RE: **204 65th Street SW**
Grading and Drainage Plan
Engineer's Stamp Date: 11/19/18
Drainage File: K11D088

Based on the submittal received on 11/19/18, the grading and drainage plan is approved for Grading Permit and Building Permit.

DRAINAGE AND TRANSPORTATION INFORMATION SHEET (REV 6/2018)

ENGINEER'S SEAL	LOT II HUBBELL HEIGHTS	DRAWN BY JDG
		DATE 11-19-2018
11/19/18	 <i>Rio Grande Engineering</i> 1606 CENTRAL AVENUE SE SUITE 201 ALBUQUERQUE, NM 87106 (505) 872-0999	SHEET # 1 OF 1
DAVID SOULE P.E. #14522		JOB #

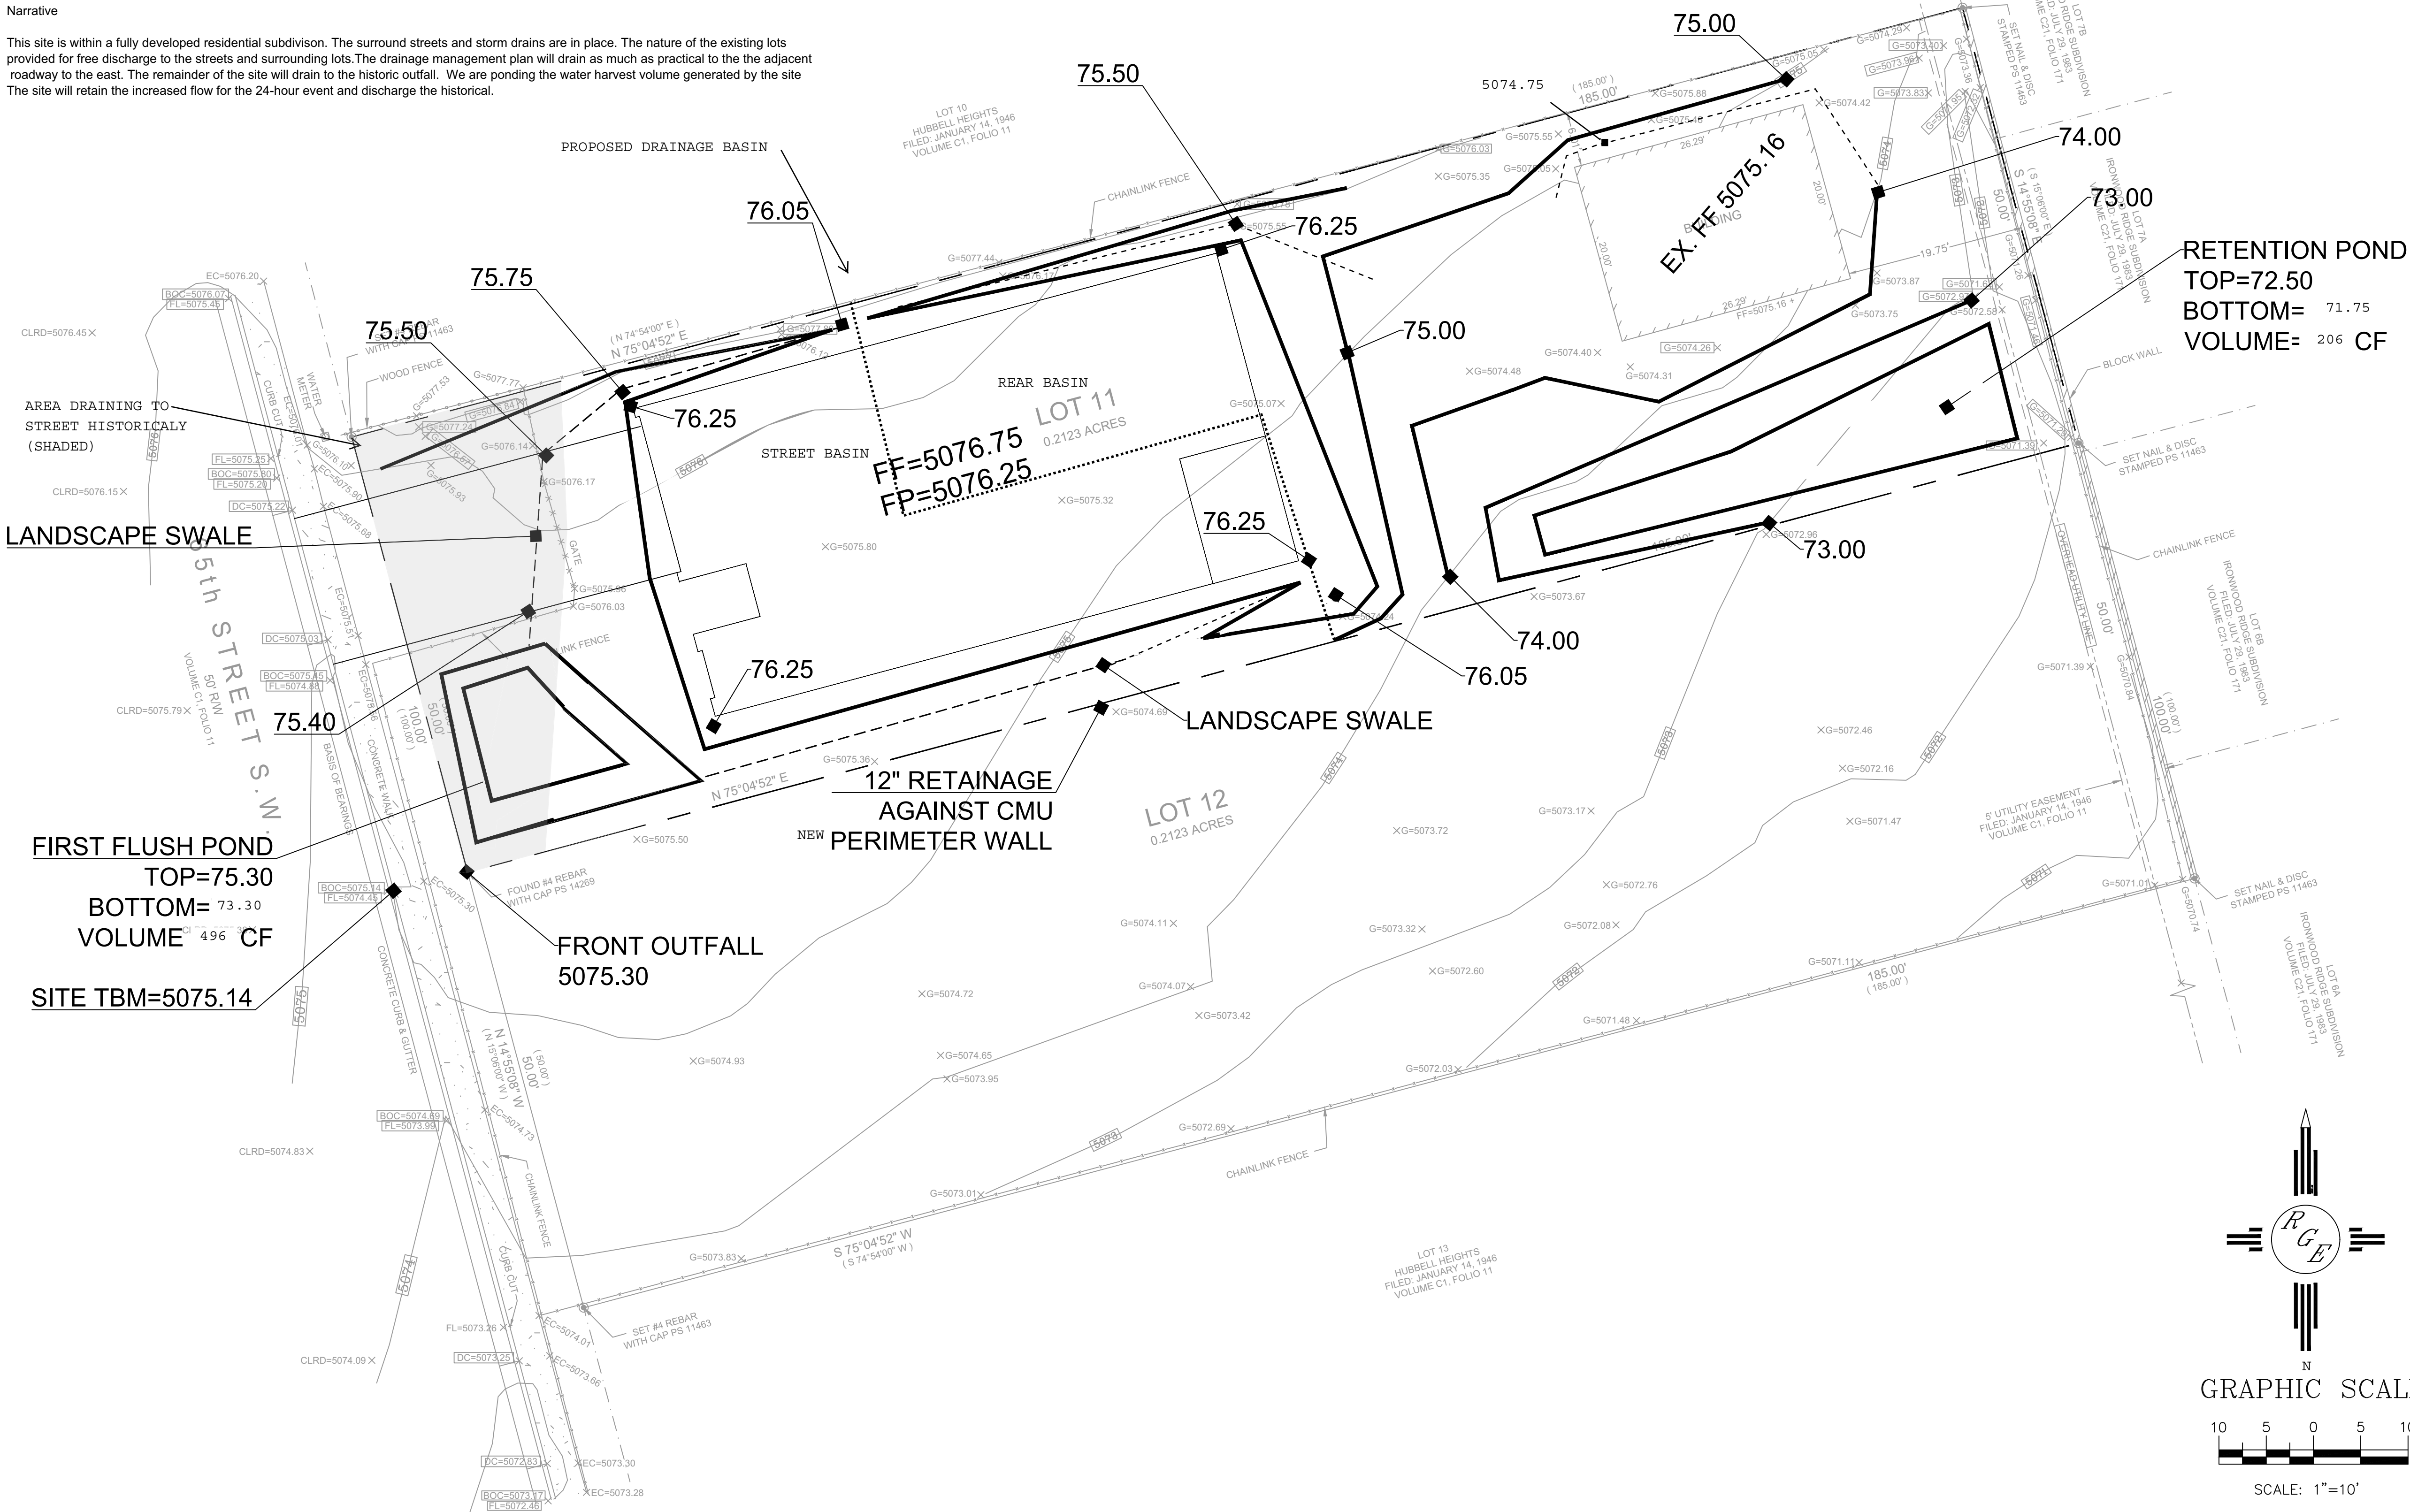
1. Engineer's Certification, per the DPM Chapter 22.7: *Engineer's Certification Checklist For Non-Subdivision* is required to ensure the ponds and the grades along the property lines were not disturbed during home construction.
